GREATER NEW HAVEN WATER POLLUTION CONTROL AUTHORITY

ADDENDUM No. 2

**WASTEWATER LABORATORY CONVERSION PROJECT
PROJECT NO. SSF 2018-04
245 EAST SHORE PARKWAY
NEW HAVEN, CONNECTICUT**

P1.100

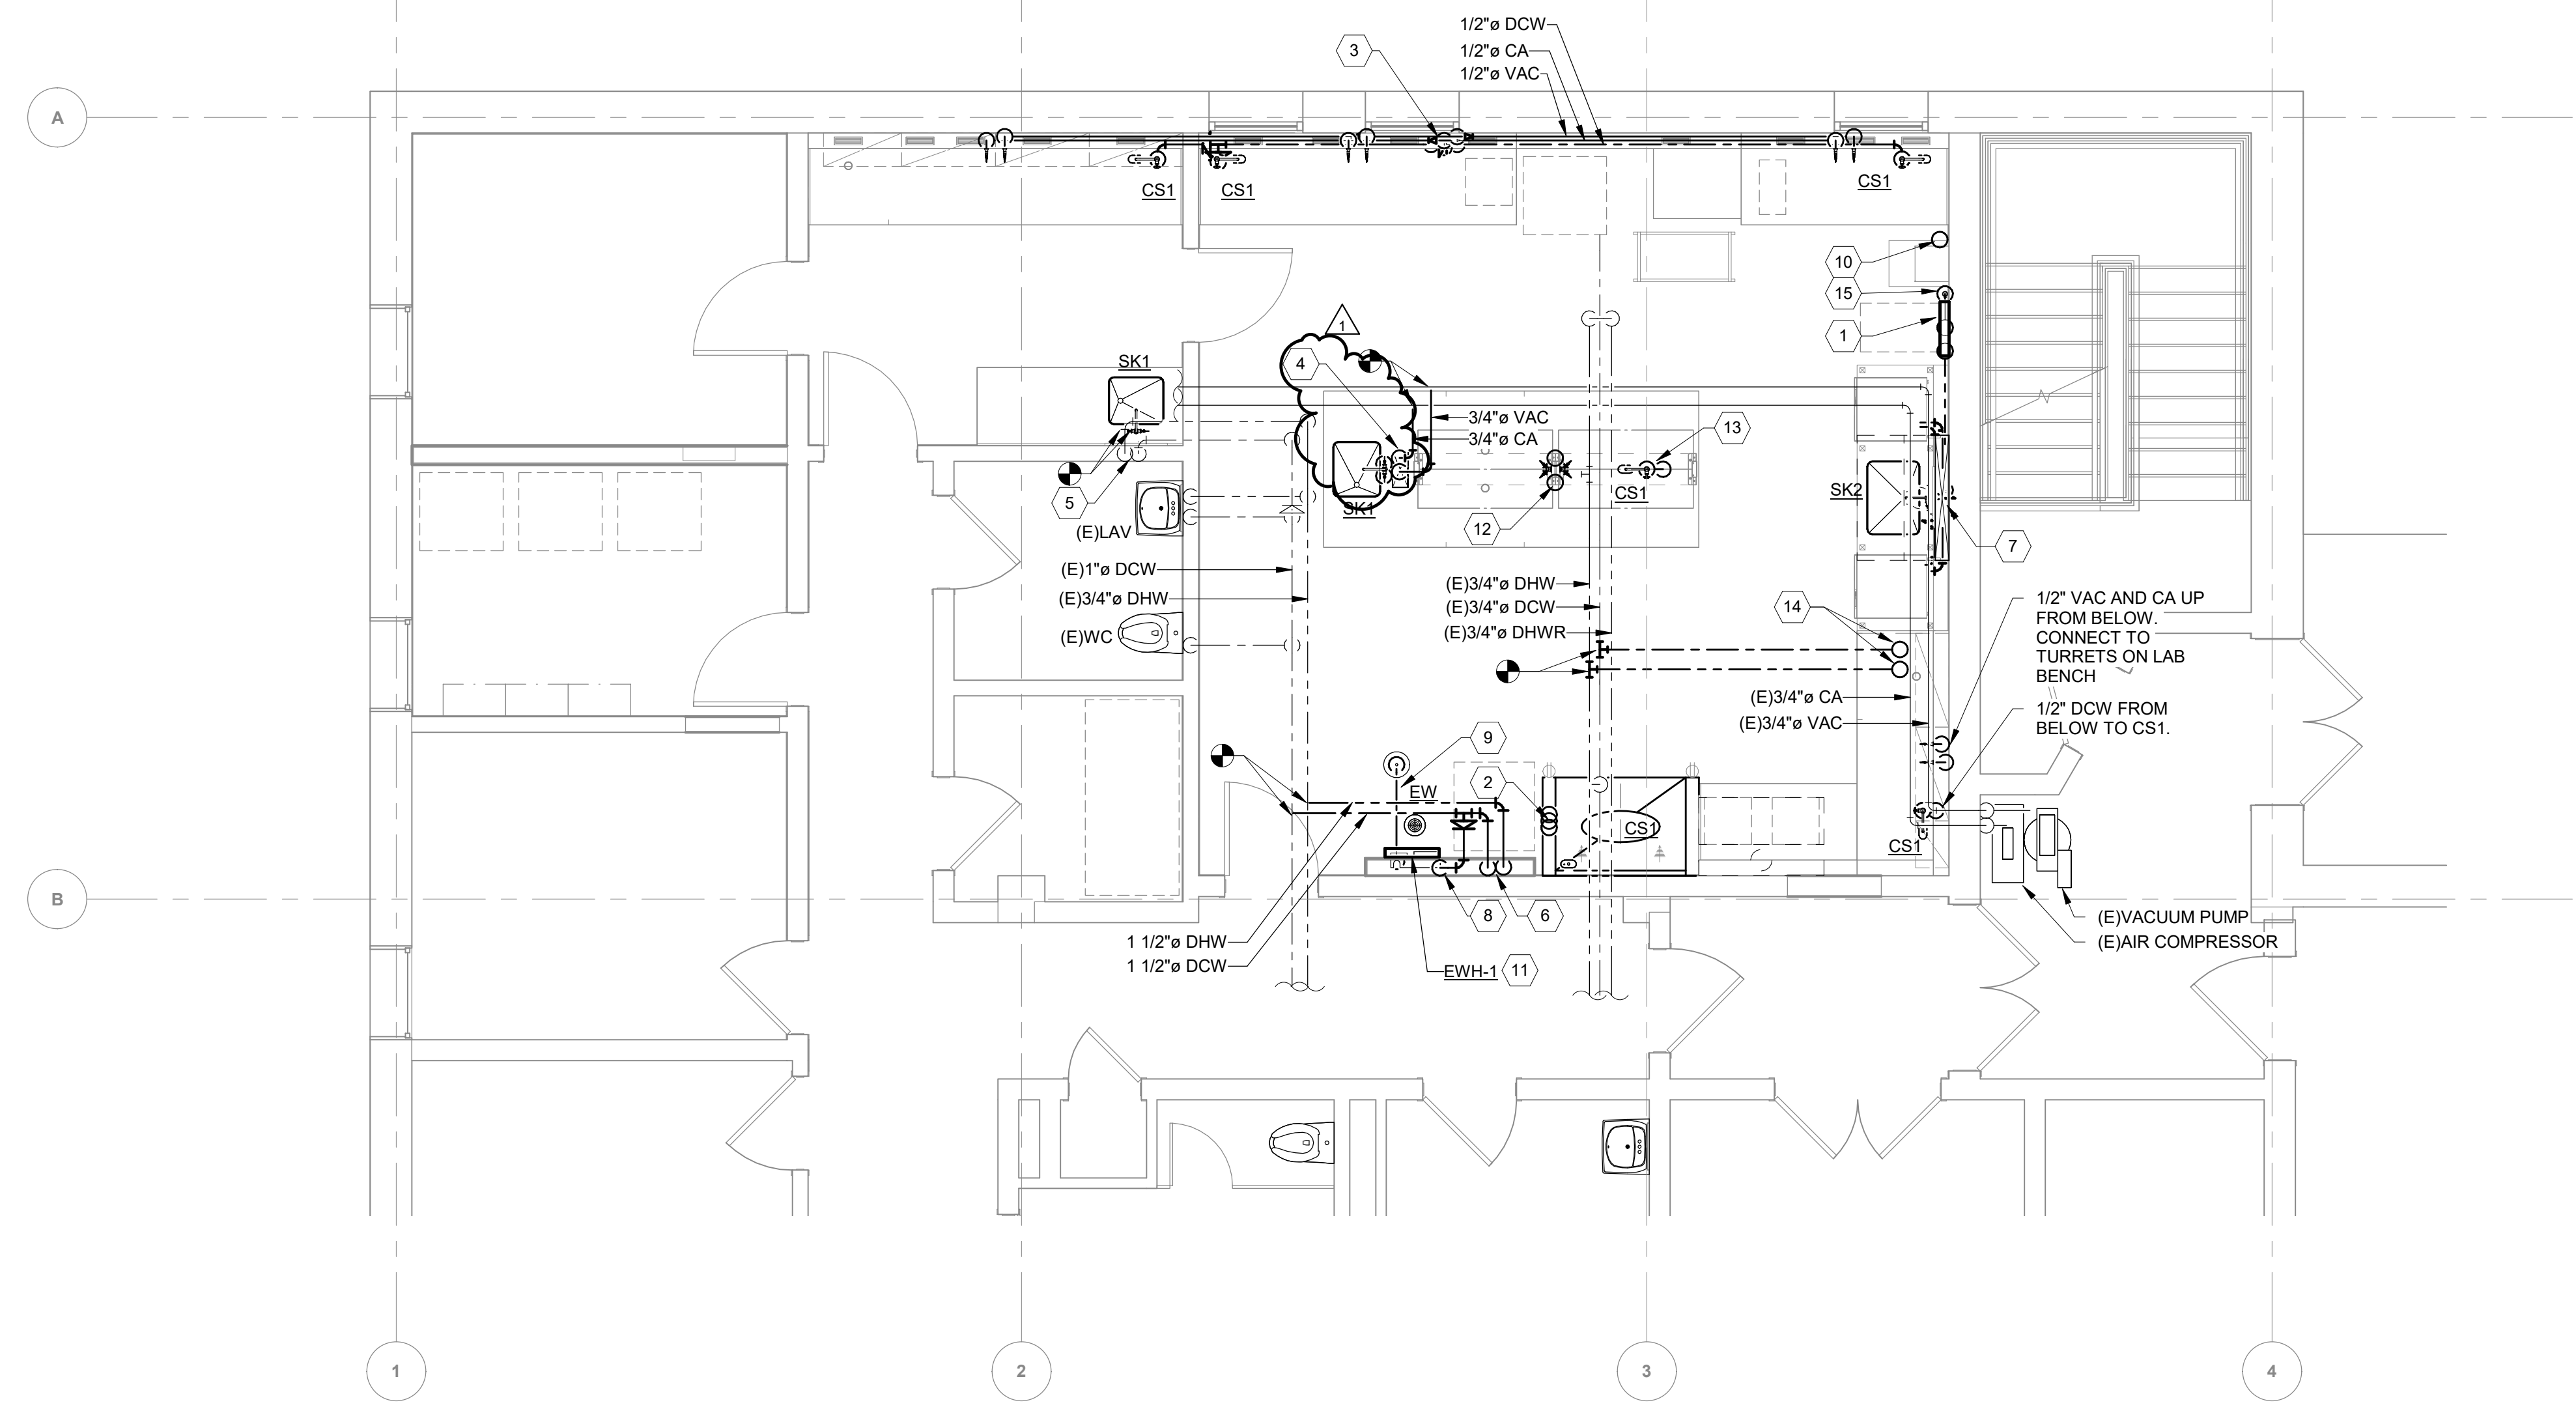
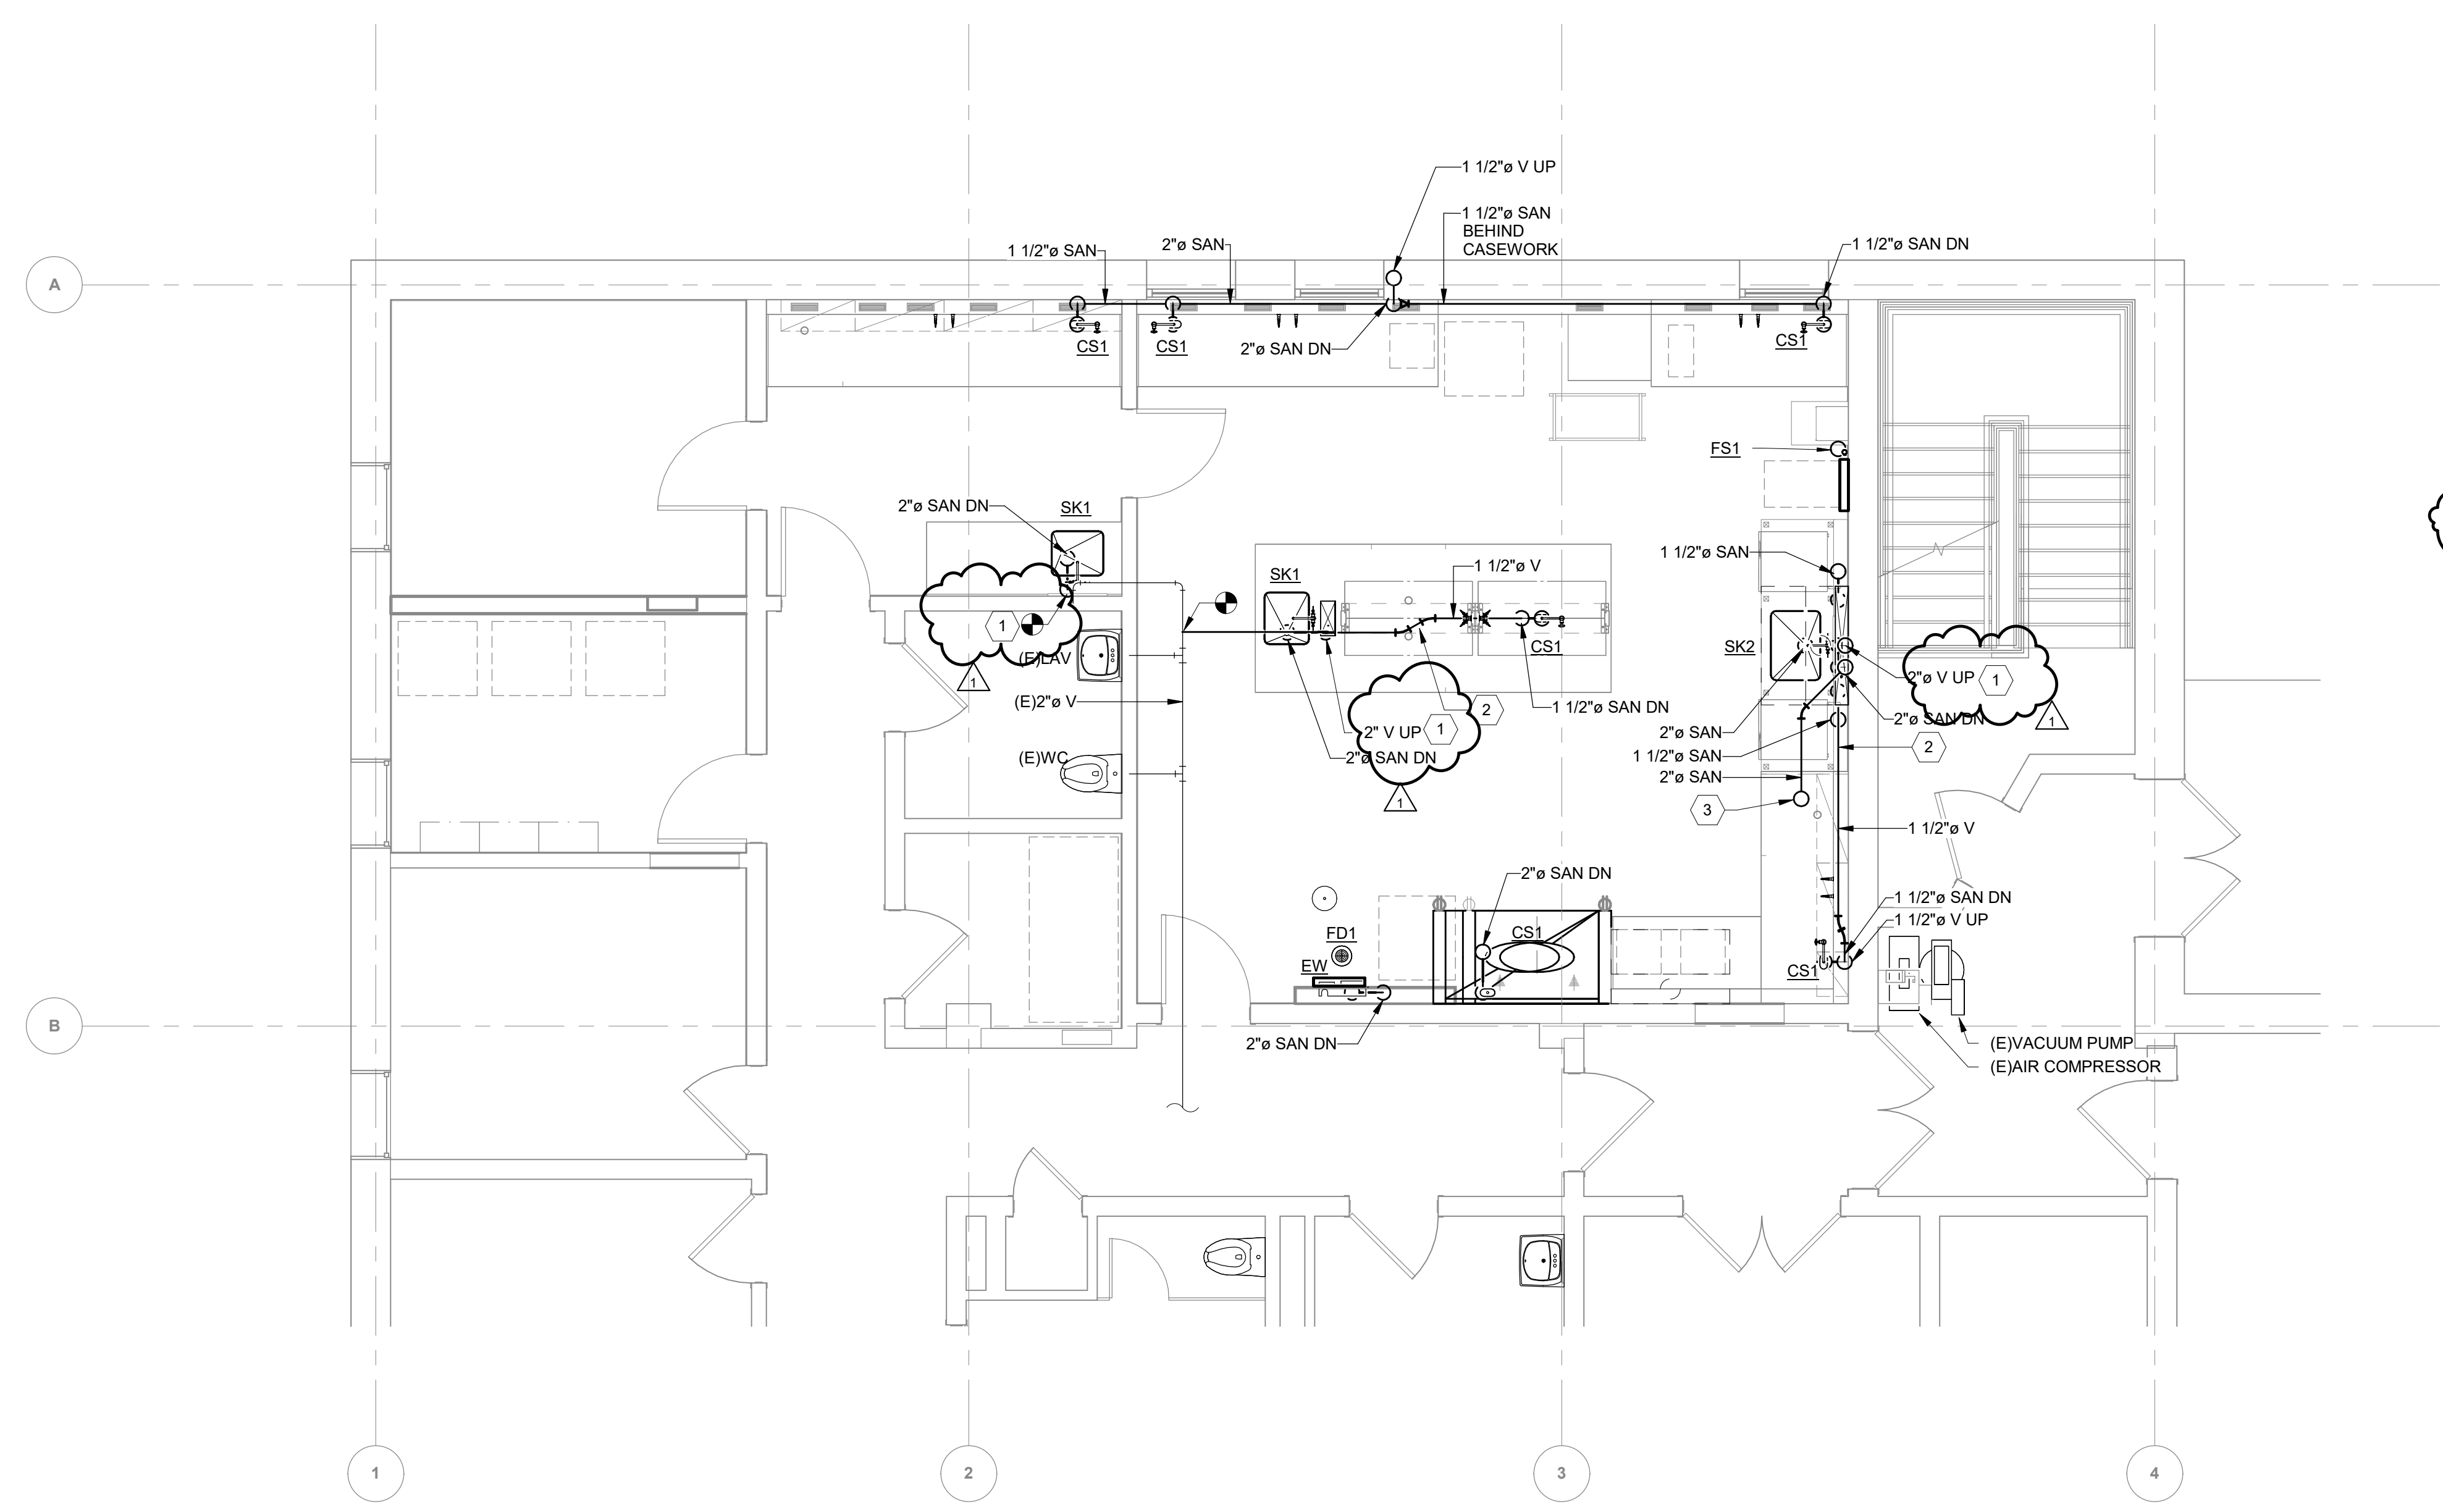
Question 27: On Sheet P1.100 Sanitary Drainage Plan - Level 1, the legend lists two keynotes: #1 and #2. However, the plan references two keynotes labeled #2 and one keynote labeled #3, which does not match the legend. Please clarify this discrepancy.

Question 38: 1. We found some discrepancies between the keynotes and drawings on sheet P1.100. Please advise.

- Keynote #7 refers to SK3, but the plan shows SK2.
- Keynote #5 refers to SK2, but the plan shows SK1.
- Keynote #4 does not refer to any sink, but the plan shows SK1.

Response 27: Keynotes will be clarified on Drawing P1.1000 provided with this addendum.

- SK3 changed to SK2 in Keynote #7. See Updated P1.100 attached to this addendum.
- SK2 changed to SK1 in Keynote #5. See Updated P1.100 attached to this addendum.
- Keynote #4 refers to VAC and CA piping in piping chase behind SK1. Keynote leader has been shifted to clarify. See updated drawing P1.100 attached to this addendum.
